Technical Service Bulletin

Subject: SQUEAKING OR RUBBING NOISE WHEN OPENING/CLOSING FRONT DOOR	Bulletin No.: 09-022/23
	Last Issued : 07/26/2023

2024 CX-90

DETAIL OF A

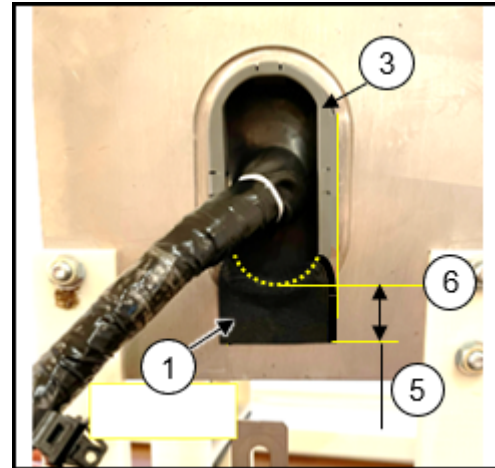
The harness interferes with the bottom edge of the door harness grommet.

4. Apply the non-woven fabric(s)(1) to the front door(s)(2) according to the following images.

- The right edge of the non-woven fabric must be aligned with the door harness grommet (3).
- Fold the remaining non-woven fabric over the other side of the hole.

(5) 15 mm (0.6 inches) from the underside of the hole (6) of the door harness grommet (3)
